**From:** Anna Williams  
**Sent:** 5/06/2024 4:32:38 PM  
**To:** Council Northernbeaches Mailbox; Maxwell Duncan  
**Cc:** Jeff Annesley  
**Subject:** TRIMMED: Submission objecting to amended plans 89 Marine Parade Avalon  
**Attachments:** Submission Amended plans Annesley 89 Marine Parade Avalon.pdf;

**RE: DA2023/1780 New Dwelling and swimming pool at 89 Marine Parade Avalon**

**Figure 1:** Section shows the relationship between bedroom 3 and the principal indoor and outdoor living areas of No. 87 Marine Parade, which will be substantially overlooked by the bedroom 3 window. **Source:** Annabelle Chapman Architect  
**Annotation:** Blackwattle Planning

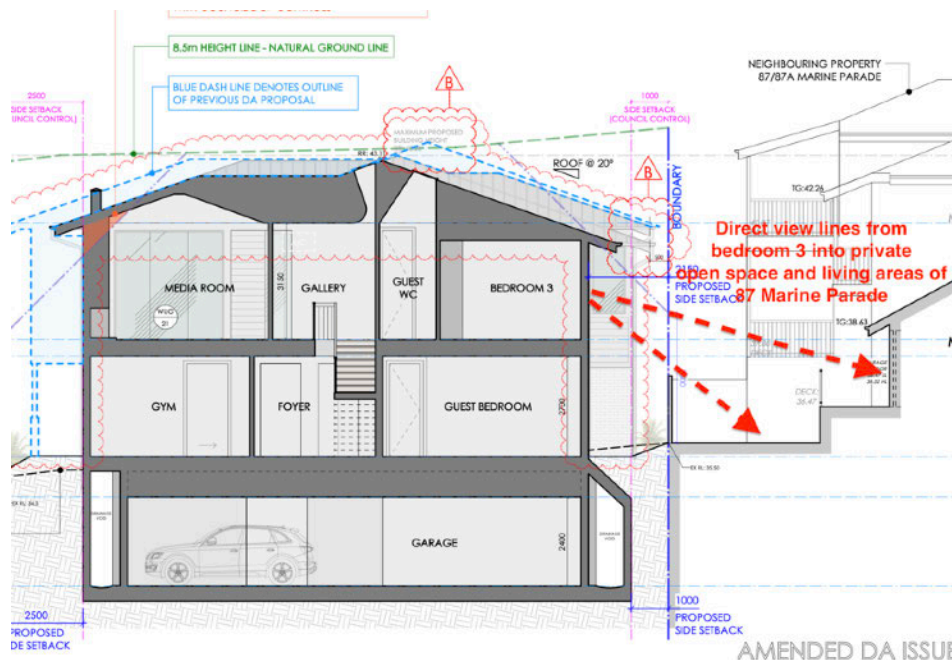
We appreciate the removal of the previously proposed balcony on the southern elevation. The window to bedroom 3 however remains a substantial overlooking impact upon the private open spaces and living area of No. 87 Marine Parade. WUG-6 will have direct view lines into this highly used area of No. 87 Marine Parade, as demonstrated below:

We object to the screen planting in the form of the proposed *Eleocarpus Eumundii* as appropriate in these circumstances to overcome the impact. We note that within the Sydney Region this species is known for its slow growth rate. The species chosen would need to be at over 80% of its design height before providing any meaningful intervention of site lines from bedroom 3.

In any event, and as previously outlined, it is a well established planning principle (*Super Studio v Waverly Land and Environment Court Planning Principle*) that landscaping should not be relied upon as the only mitigation of overlooking. In particular, Senior Commissioner Roseth states the following:

Noting the above, and in accordance with P21DCP, we request that screening measures (other than landscaping) to a height of 1.65m above finished floor level be applied to WUG-06 of bedroom 3 to resolve the substantial impact.

**Figure 3:** Extent of Building Envelope breach outlined in blue dotted.

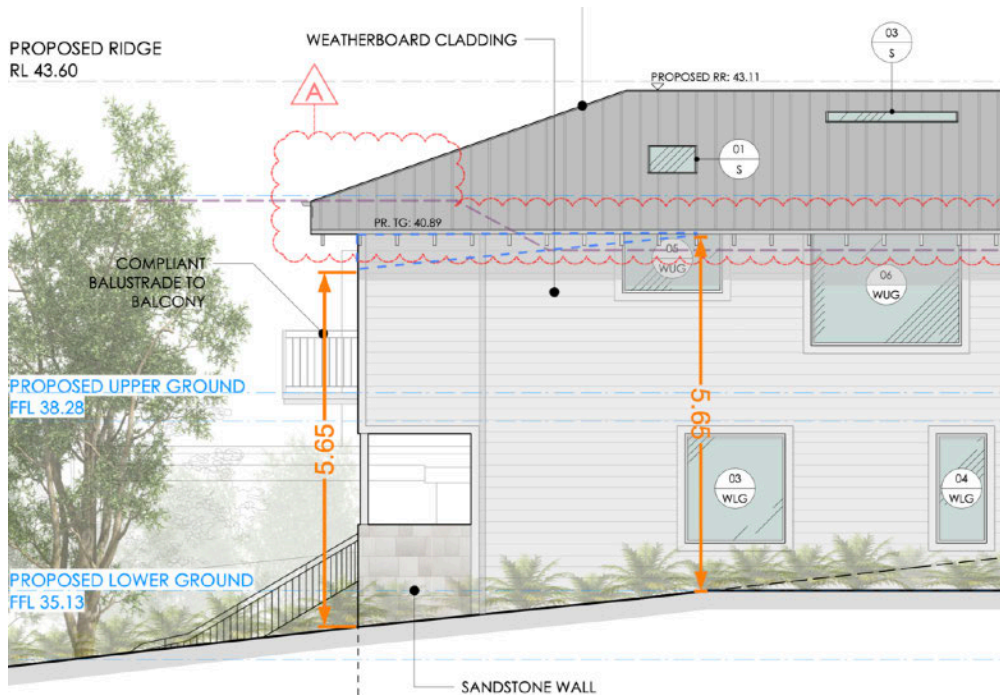
We cannot agree, and note that no sectional information is provided through the western end of the proposed dwelling where the building envelope breach is greatest. Our own calculation of the remaining building envelope breach is demonstrated at Figure 3 below.

The building envelope breach remains at the point on the southern elevation where the additional bulk will be readily apparent from the primary internal living and principal outdoor living areas of 87 Marine Parade.

As previously stated, there appears to be no justifiable reason why full compliance cannot be achieved on a site with an area in excess of 1000sqm and a width of 18m+. Any design challenge relating to sloping land has been overcome entirely with the extensive excavation proposed and topographical conditions present no barrier to a complying development.

We maintain that the above objectives are still not met by the proposed. As a minimum, the design should be amended to comply with the required building envelope.
